SG ARCHITECTURE, LLC

DESIGN REVIEW APPLICATION | SUPPLEMENTAL INFORMATION

SGA PROJECT NO. 20-119

Design Review Application DR-23-01  
Supplemental Information Submittal in  
Response to Incomplete Notice

**1 GROUND FLOOR PLAN + WILLAMETTE FALLS DRIVE ELEVATION**

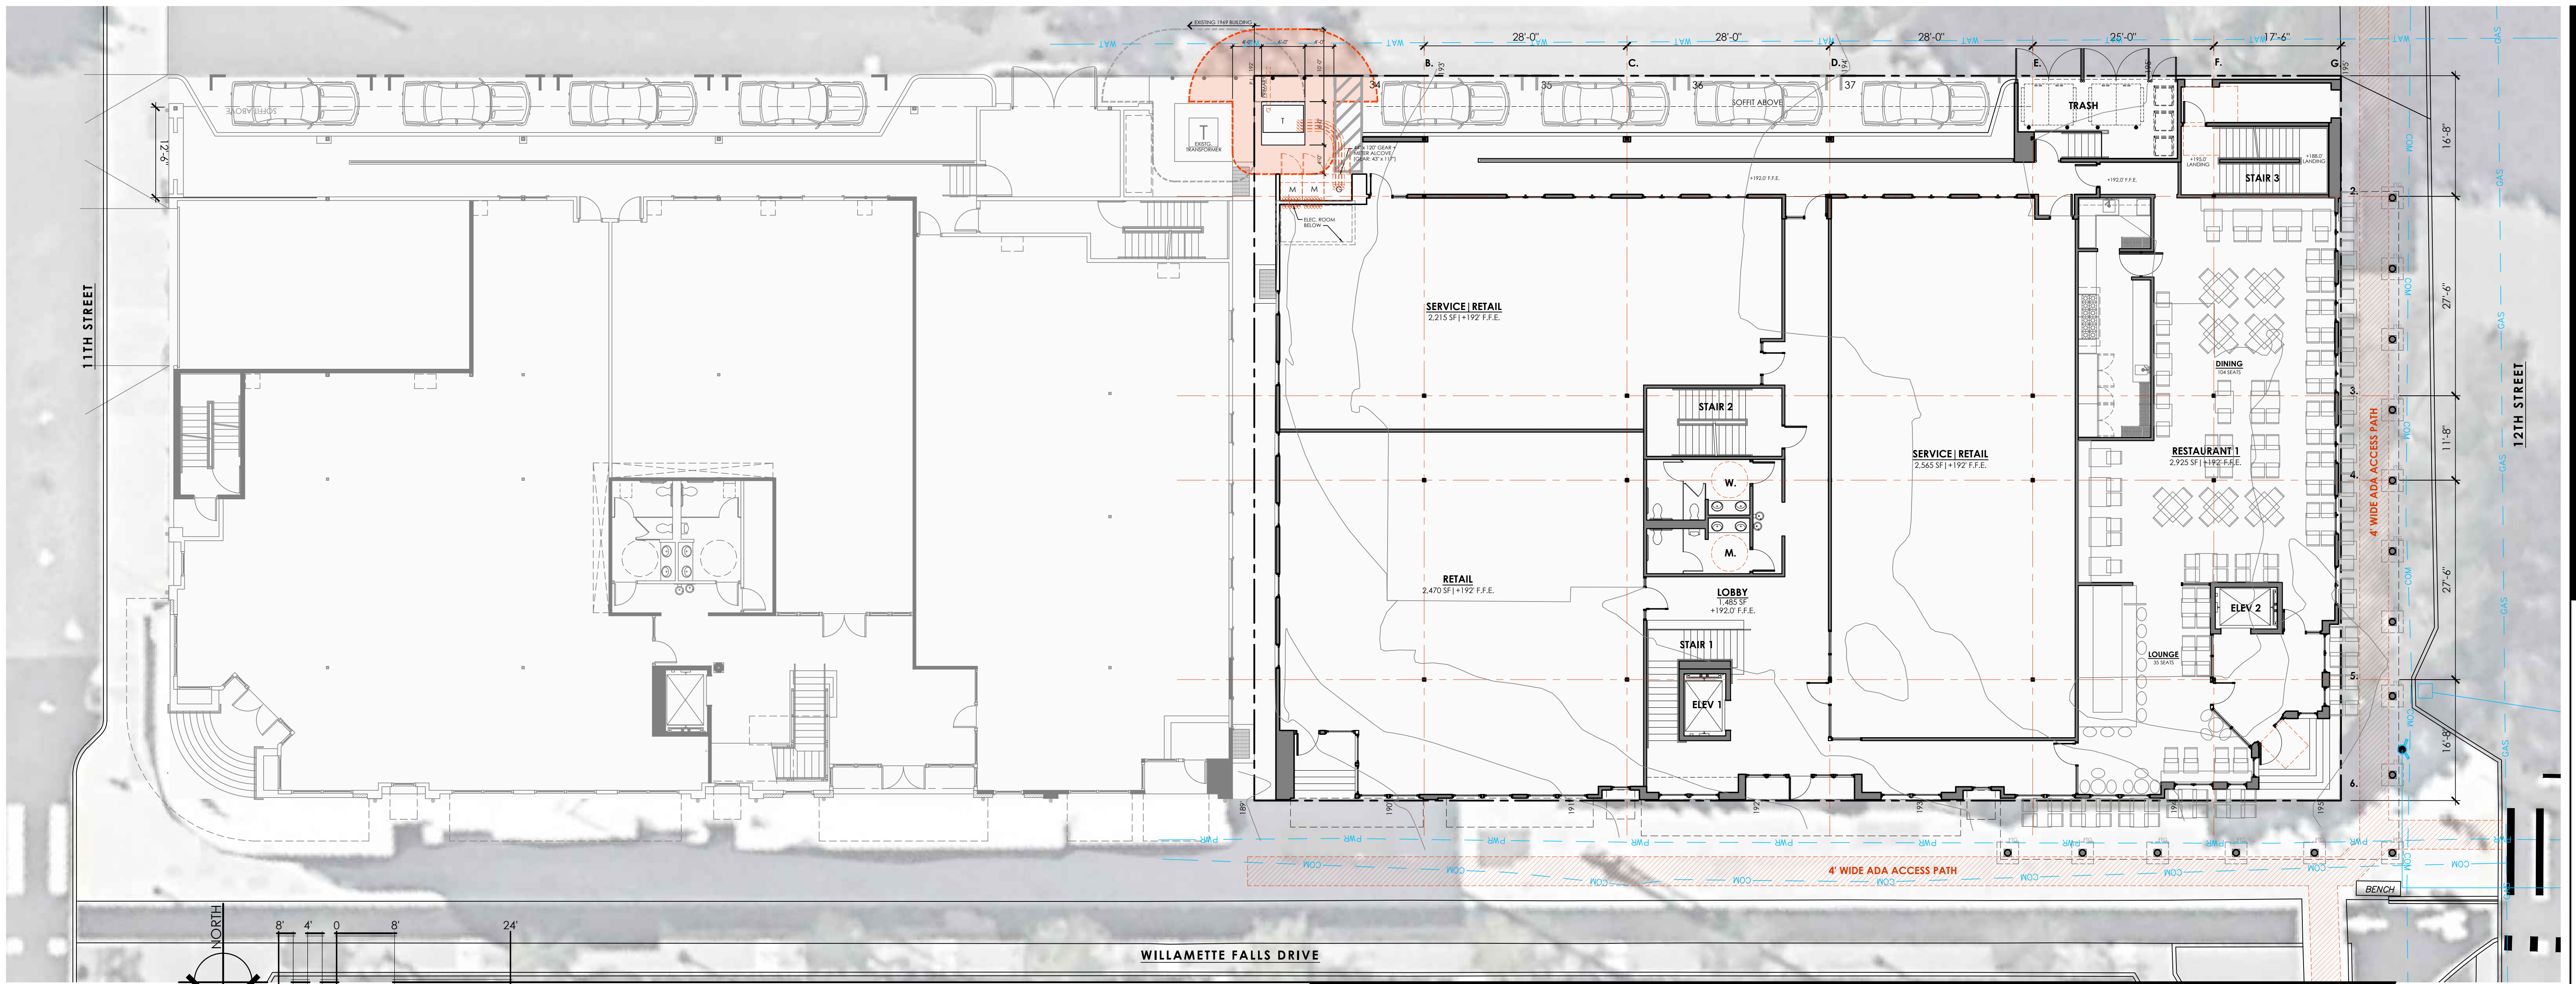
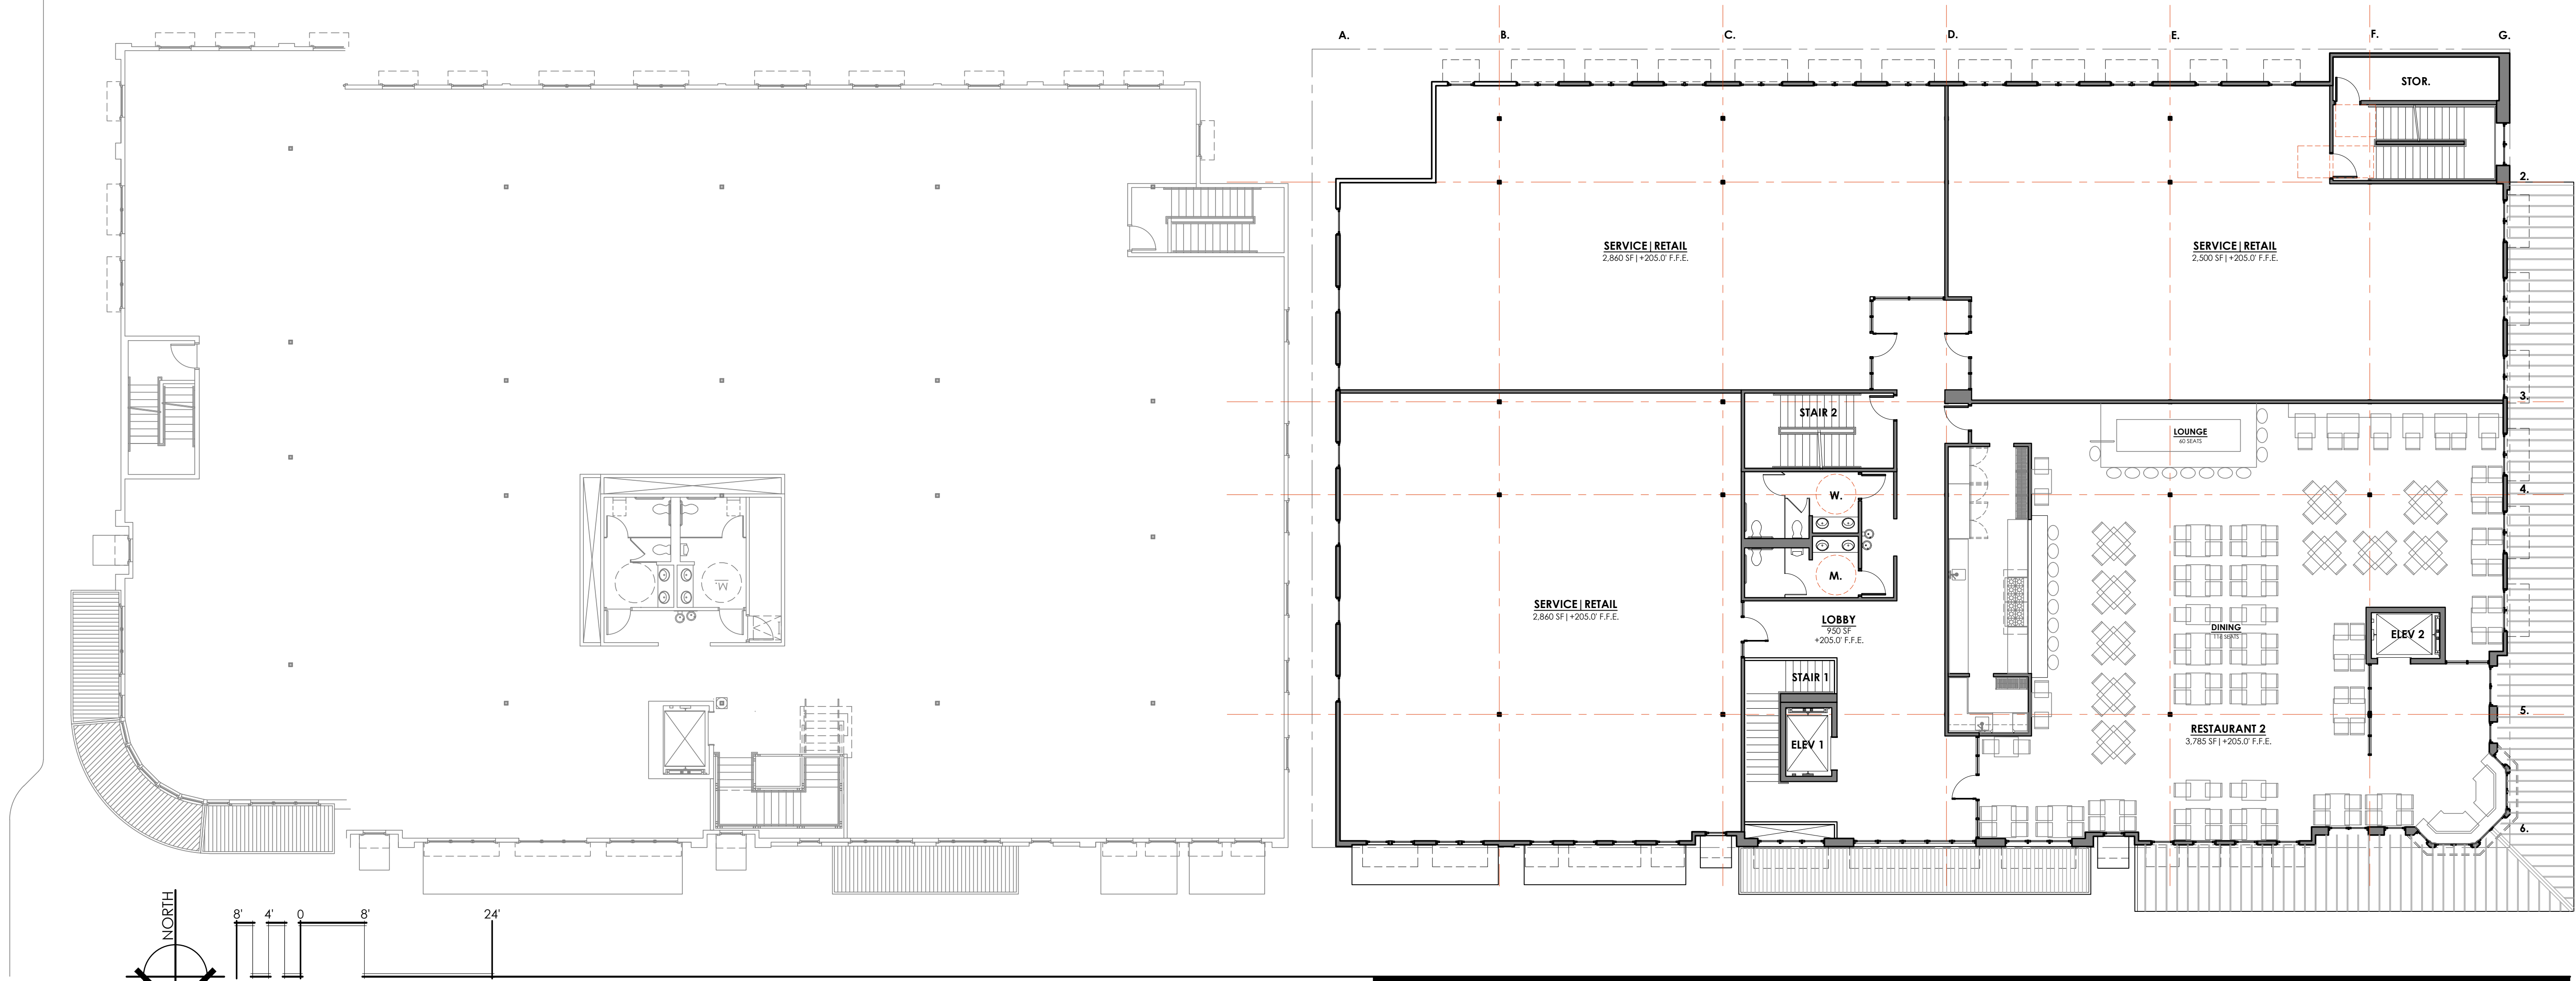
2. *Building Height. Please call out proposed building heights on all elevations per methodology in CDC 41.005 and 41.030. As a non-habitable projection, Western False Fronts are exempt from the height limit.*

- c. Please provide a proposed outdoor seating layout along both Willamette Falls Drive and 12th Street, including clear demarcation of the ADA path.

**The drawing "1949 MIXED USE.1949 WILLAMETTE FALLS DRIVE.03\_WFD ELEVATION (0420)" has been updated to include illustration of the building's compliance with the 35' height limit standard at a point 5' out from the front of the building/property line per Section 41.005.**

**These footings have been shown on the Ground Floor Plan (see "1949 MIXED USE.1949 WILLAMETTE FALLS DRIVE.03\_WFD ELEVATION (0420)"), along with the current site utilities. As shown, there should be little chance of conflict. In addition, the bottom of the footings are proposed at approximately 20" below grade, which should place them well above any utility lines nearby.**

**The Exhibit "1949 MIXED USE.1949 WILLAMETTE FALLS DRIVE.03\_WFD ELEVATION (0420)" exhibit has been updated to show a possible outdoor seating layout. Any outdoor seating would be required to conform to the CDC Section 7.950 "Sidewalk Café Program".**

**2** SECOND FLOOR PLAN + EAST & 12th STREET ELEVATIONS

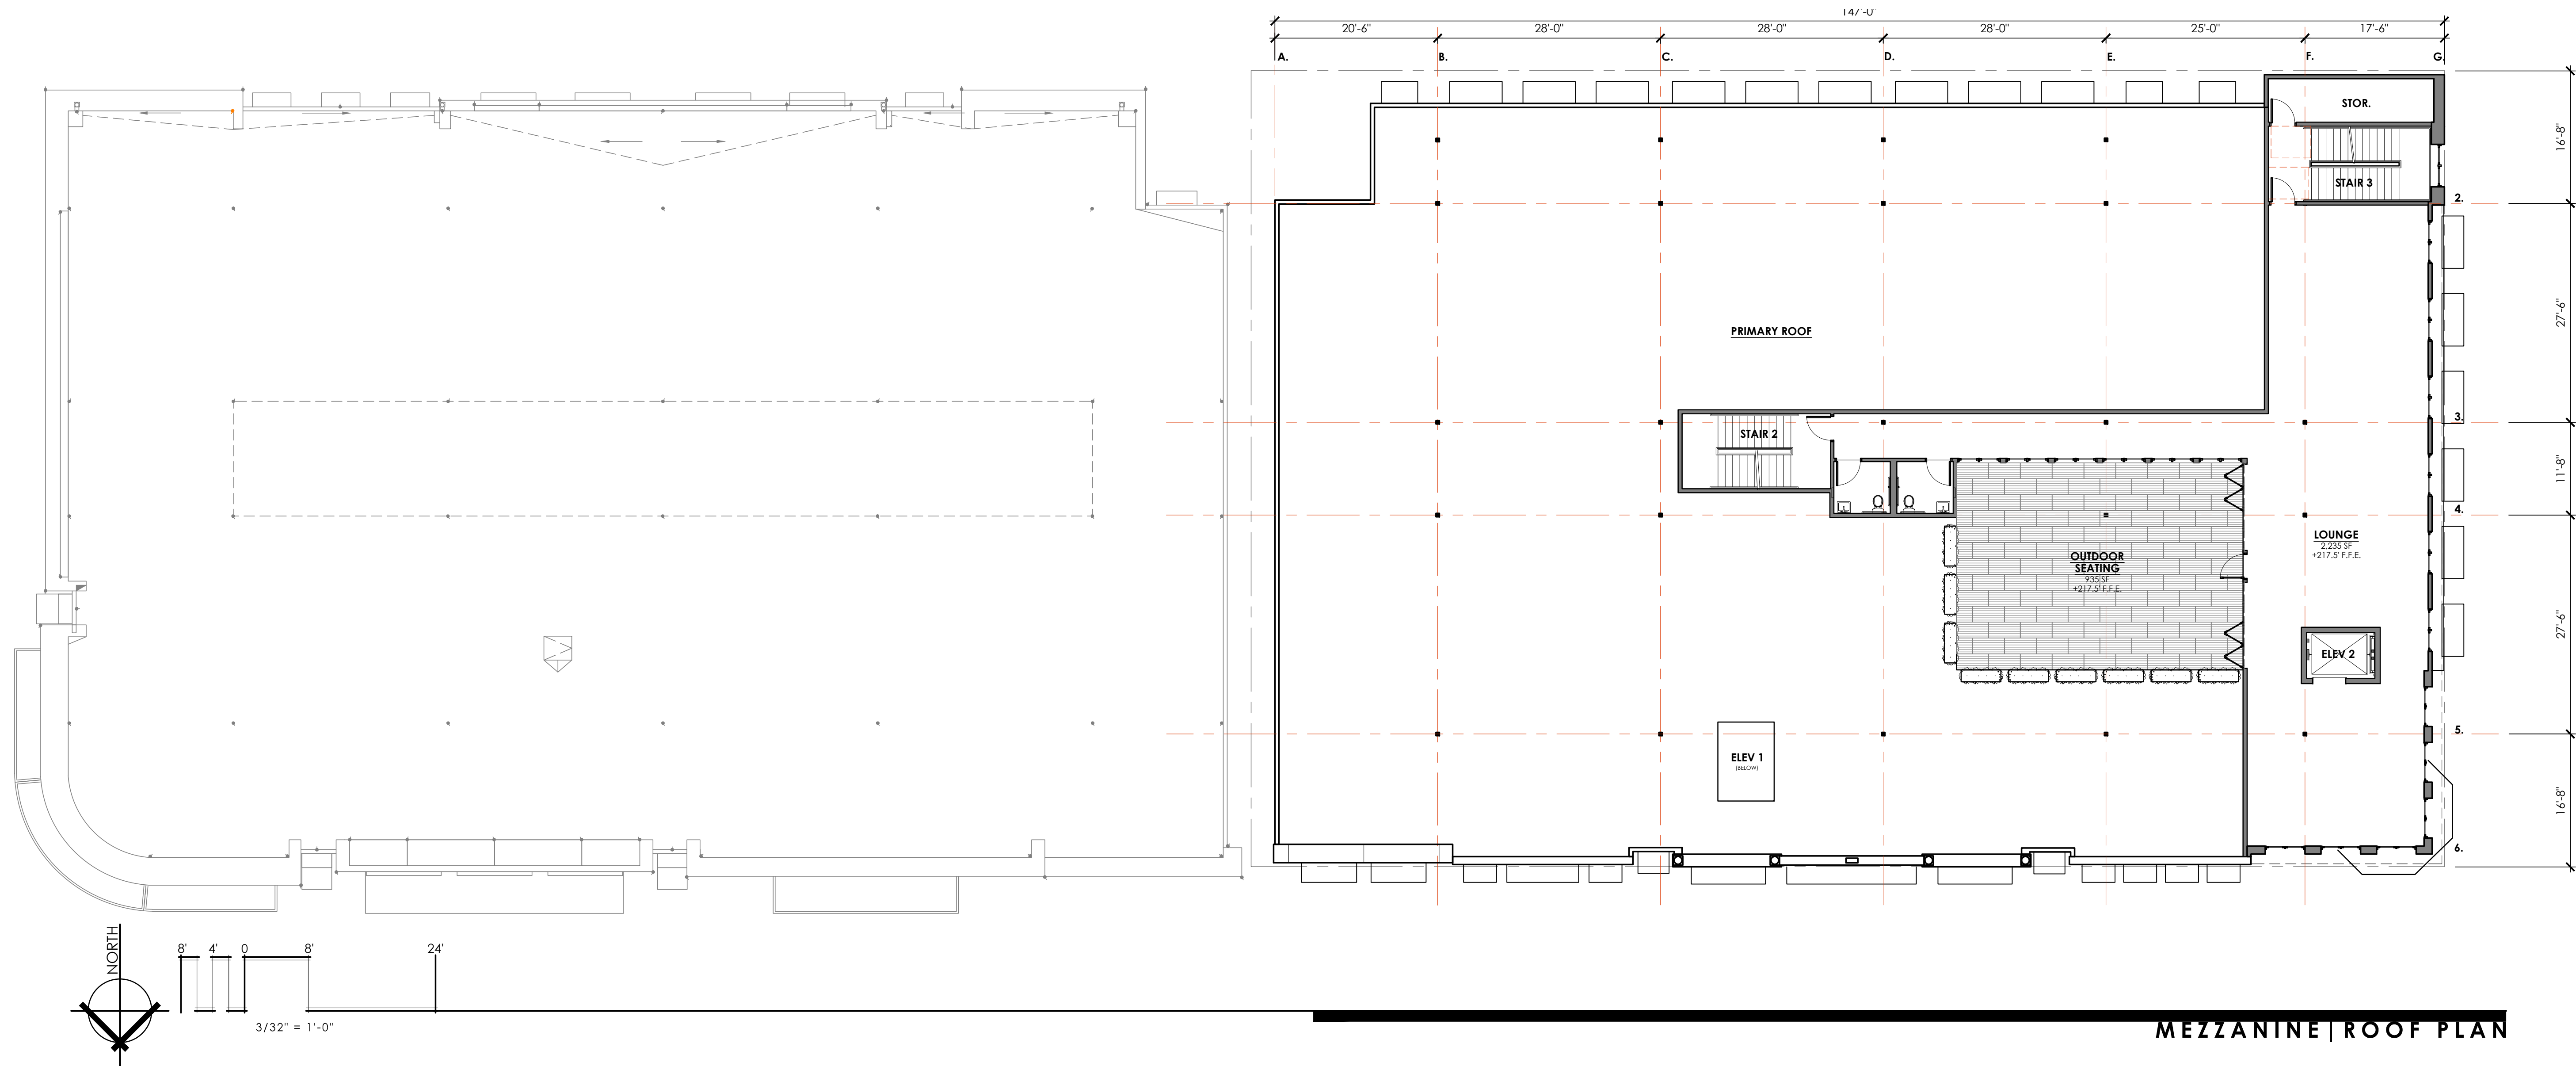
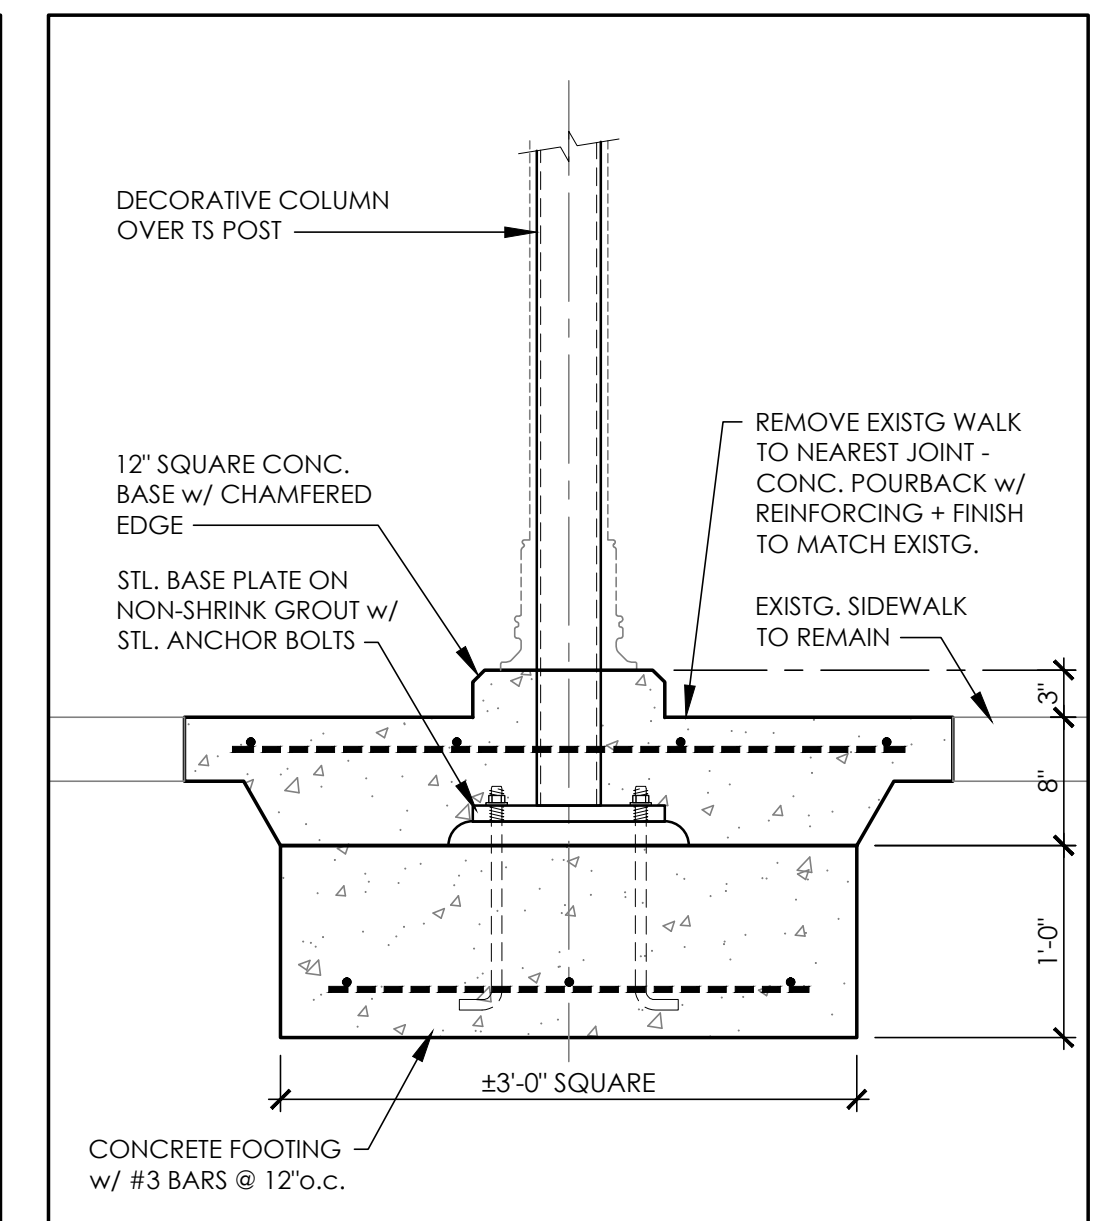
- b. Due to concerns about potential utility conflicts with the pillars proposed along Willamette Falls Drive, please provide a detail in the plans showing how the posts will be anchored to the sidewalk. Will the posts be embedded in the sidewalk or just anchored/bolted down at the surface of the sidewalk? There may need to be 2 different anchoring details – one for wherever the posts are anchored to concrete and one for where the posts are anchored in landscaped area (i.e. along 12th St.).

**The Exhibit "1949 MIXED USE.1949 WILLAMETTE FALLS DRIVE.04\_12TH STREET ELEVATION (0420)" has been updated to include a footing detail for the canopy posts. The design proposes that the existing sidewalk be removed to the nearest joints, an approximately 3' x 3' x 12'd. footing be poured, and the sidewalk poured back to match the adjacent.**
